AGENDA ITEM A Joint Item Consideration of Resolutions Transmitting the Official City and Agency Response to the 2005 Final Environmental Impact Report /Statement for the Proposed Metro Mid-City/Exposition Light Rail Transit Project

FINAL EIR/EIS (the "FEIR") COMMENTS MID-CITY/EXPOSITION LIGHT RAIL TRANSIT PROJECT November 21, 2005

Figure 3 Right of Way Option

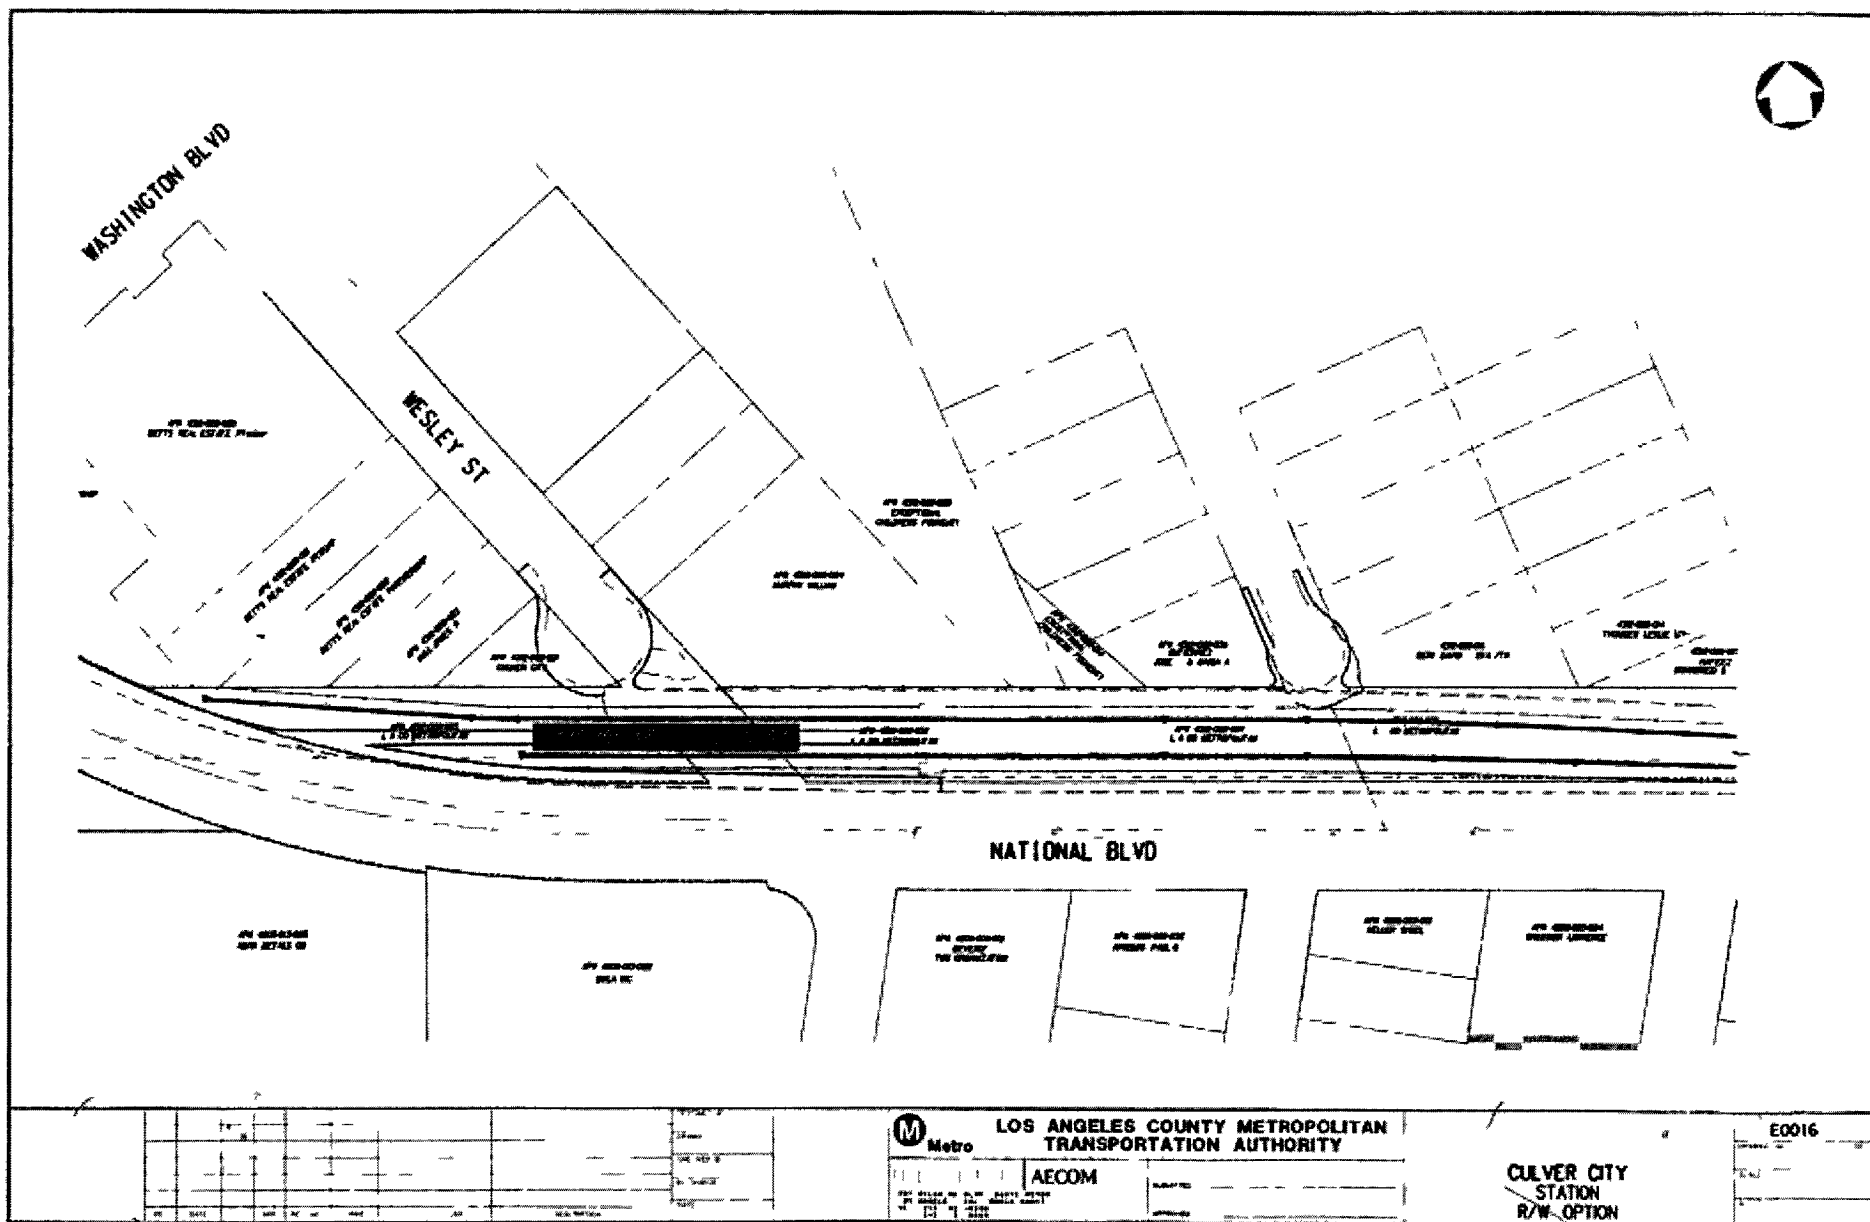
Associated Costs	More expensive - Extra cost of constructing an elevated station and approach slope - No land acquisition required	Expensive Acquisition of approximately 9826 square feet of land² required	Least expensive option - No land acquisition required - Possibility of acquiring one parcel of land to house station related facilities³	Very expensive Acquisition of 4 parcels (77 185 square feet) of land required including Spartan Lumber	Somewhat expensive Acquisition of 2 parcels (28 554 square feet) of land required	Expensive Acquisition of 3 parcels (37 369 square feet) of land required	Diminished economic potential to Culver City businesses TOD and properties near proposed Venice/Robertson station area
Pedestrian Access	Best option most direct and efficient access	Same as Aerial Design Option	Direct access from east lengthened pedestrian travel from west and north and adequate access from south Surface pedestrian crossing ⁴ incorporates the use of horns and crossing gate bells that add to overall noise level	Limited access from east good access from west south and north Surface pedestrian crossing incorporates the use of horns and crossing gate bells that add to overall noise level	Limited access from east lengthened access from west and north and adequate access from south No pedestrian crossing designated on the plan	Limited access from east lengthened pedestrian travel route from west south and north No pedestrian crossing designated on the plan	Eliminate the LRT as a barrier between the neighborhoods north and south of the Right of Way

Access to bus stops	Best ⁵	Same as Aerial Design Option	Poor ⁶	Fair ⁷	Poor ⁸	Poor ⁹	Fair ¹⁰
Access to parking	Best ¹¹	Same as Aerial Design Option	Poor ¹²	Fair ¹³	Poor ¹⁴	Poor ¹⁵	Good ¹⁶
Station Related Traffic Impact	Minimal impact	At grade crossing on Washington and National Boulevards would significantly hamper traffic operations at the intersection of these streets	Potential for impact on National Boulevard Washington Boulevard and Washington/Wesley intersection due to station related activities	Potential for impacts on Washington/National intersection and National Boulevard due to station related activities	Potential for impact on National Boulevard Washington Boulevard and Washington/Wesley intersection due to station related activities	Potential for impact on National Boulevard Washington Boulevard and Washington/Wesley intersection due to station related activities	Minimal impacts ¹⁷ to City

⁶ There is no bus line serving National Boulevard Bus riders will need to walk long distance to reach the bus stops at Washington/National intersection and even longer to reach the bus stops on Venice Boulevard

¹² Station location is far from major parking (735 parking spaces) location north of Venice Boulevard

Figure 4 North of Right of Way Option A

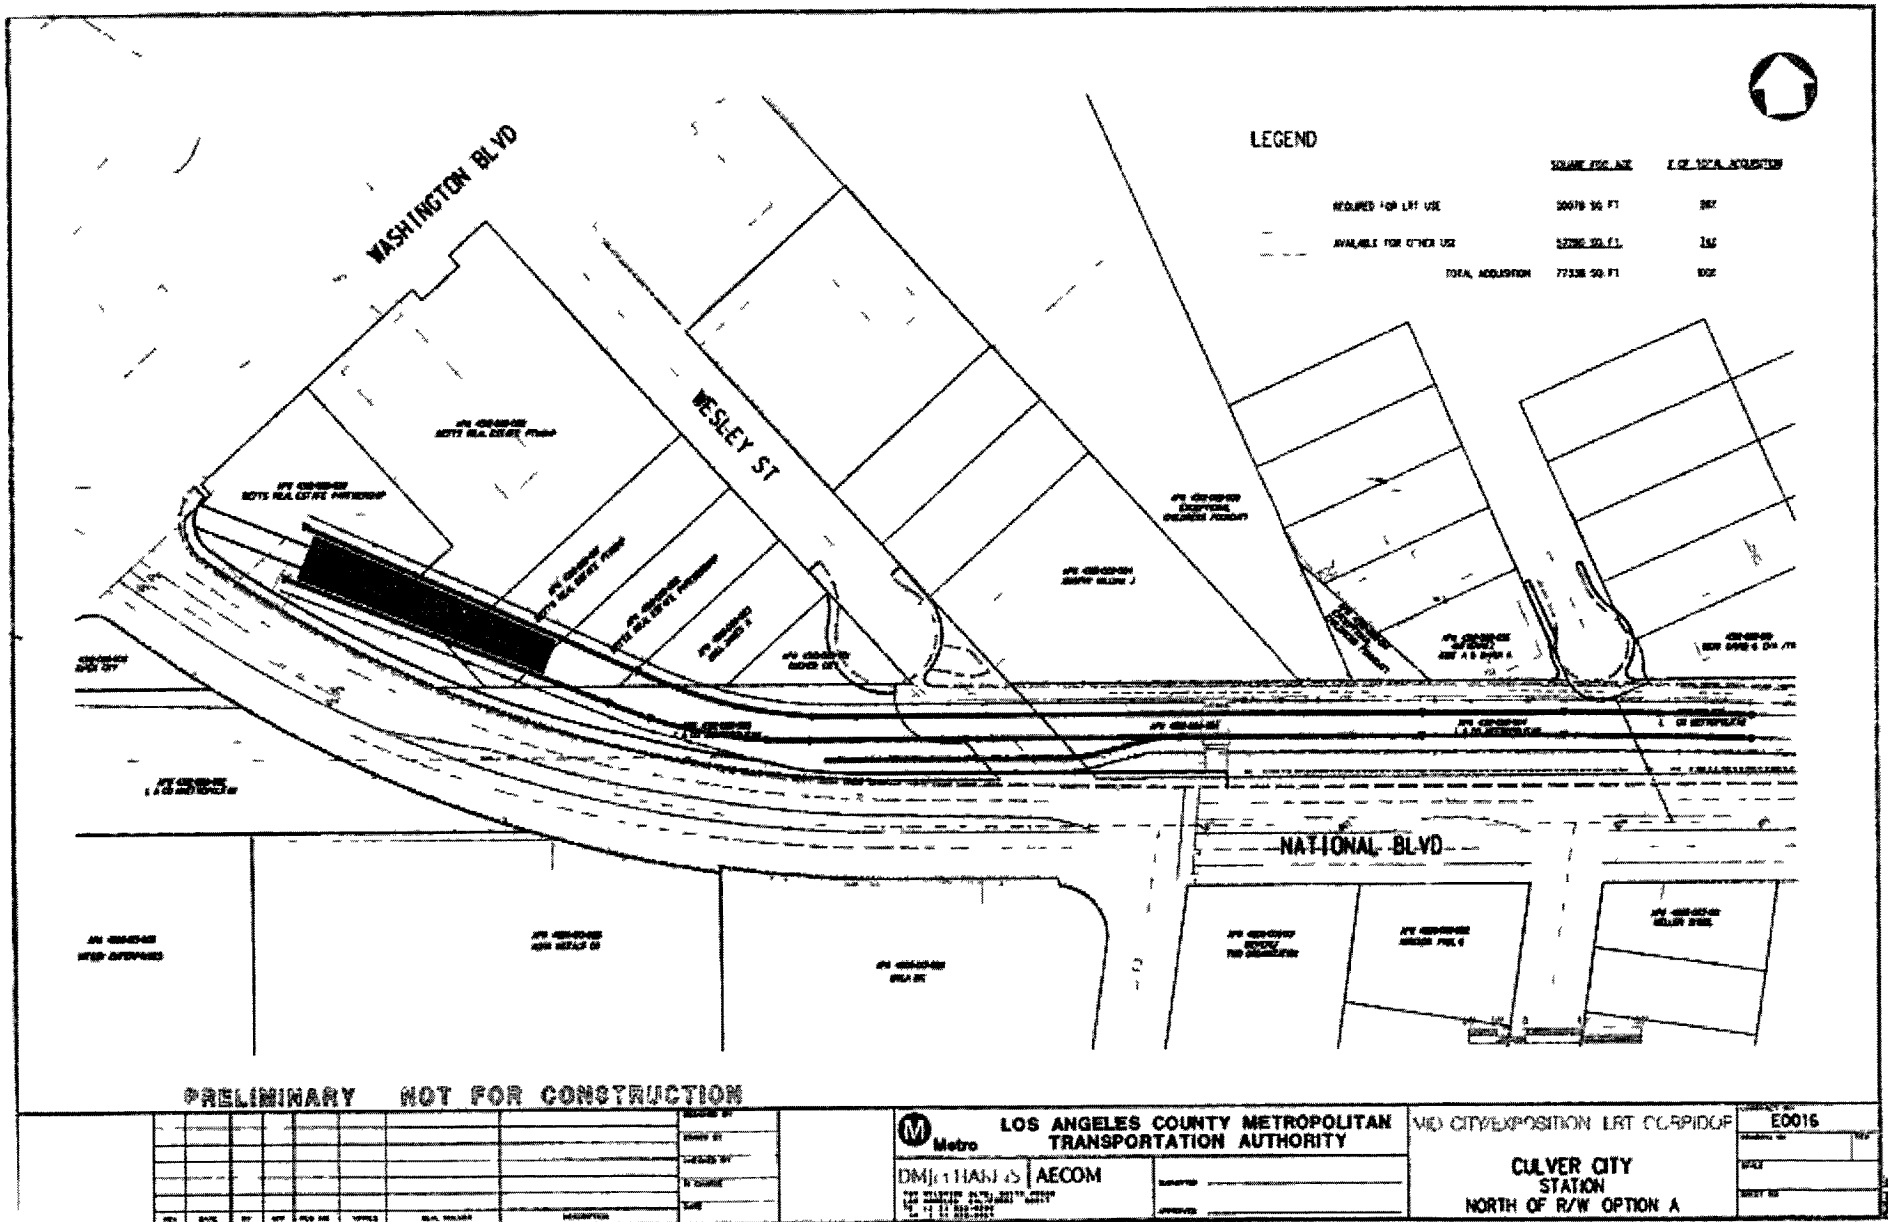
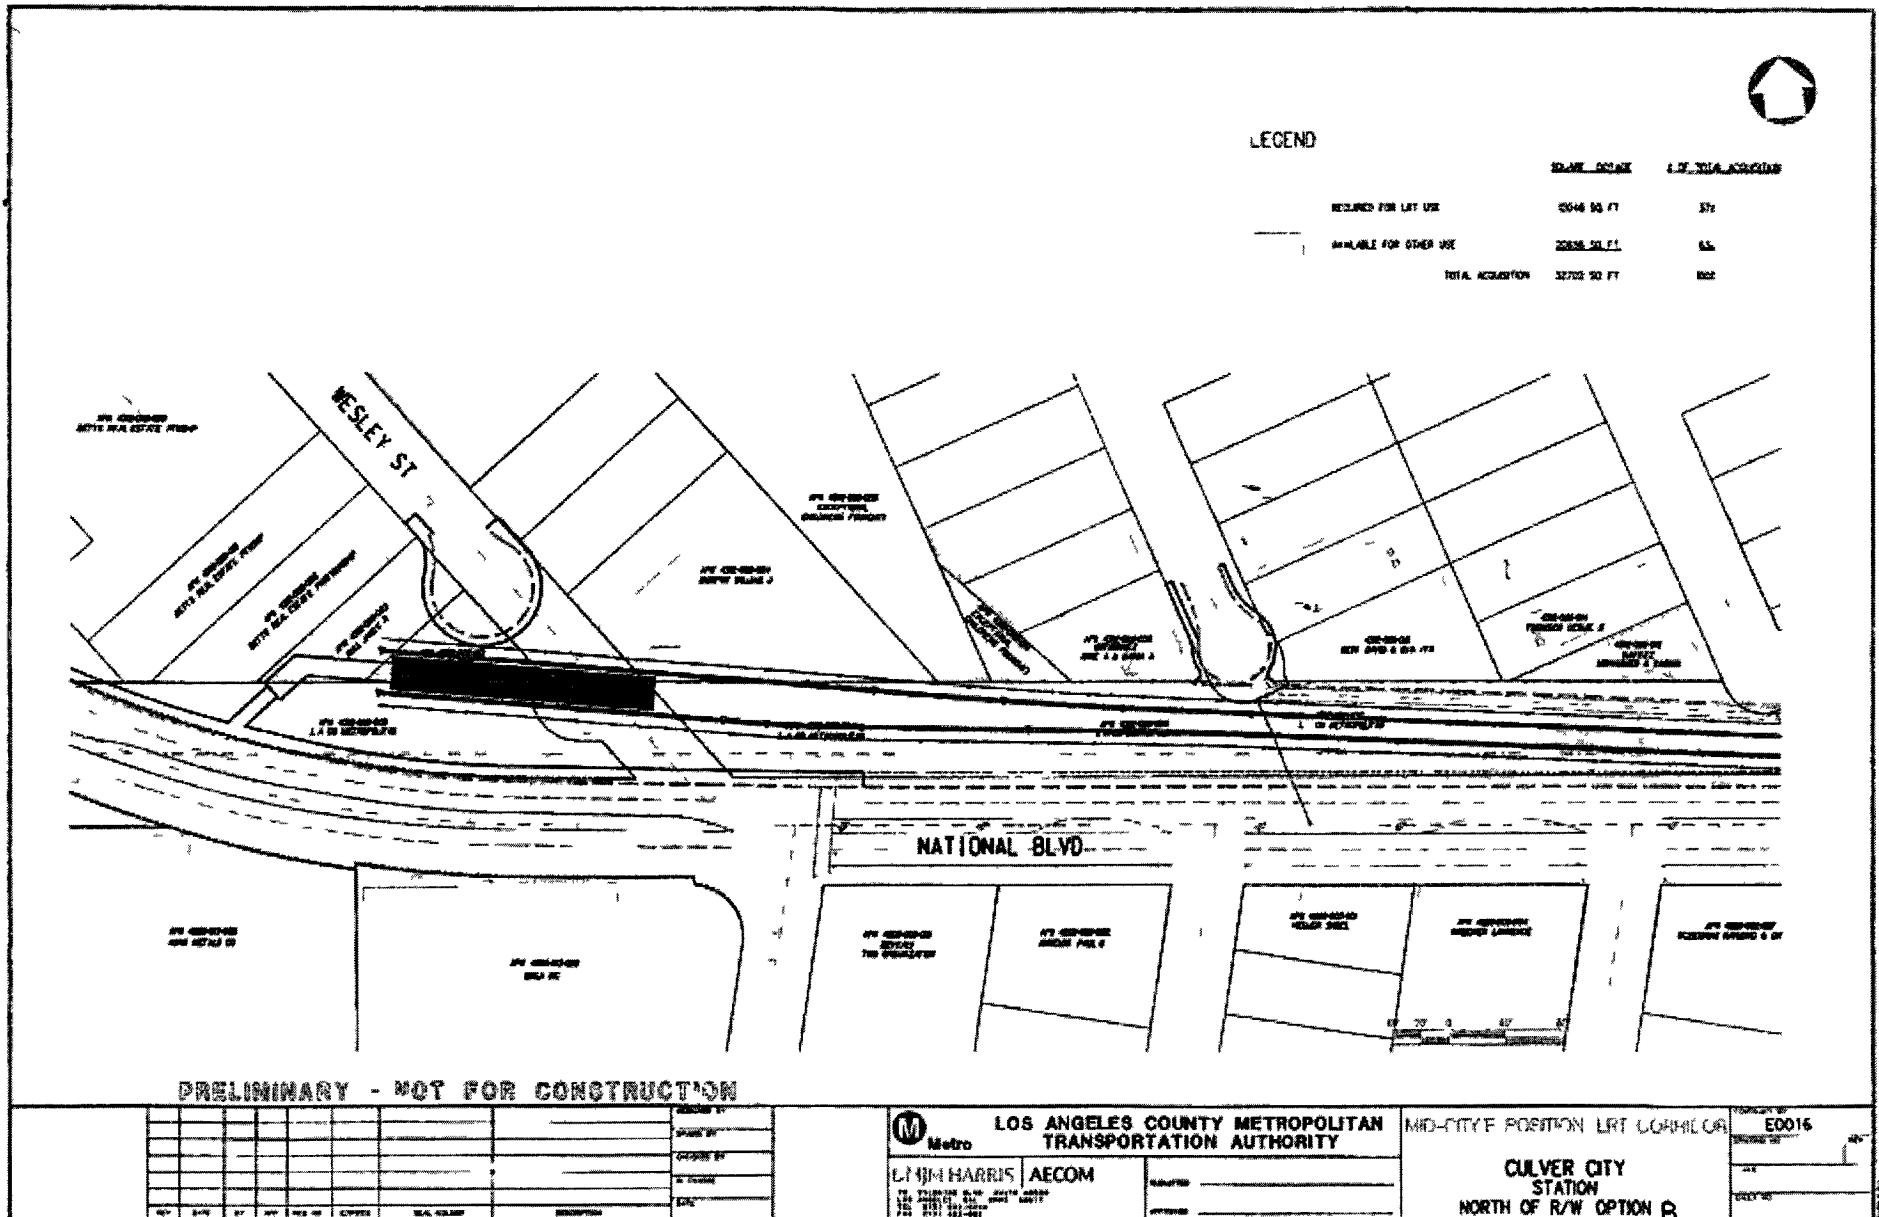
⁷ Station location is close to bus stops on Washington Boulevard but far from bus stops on Venice Boulevard.

¹³ Station location is somewhat closer to major parking (735 parking spaces) location north of Venice Boulevard
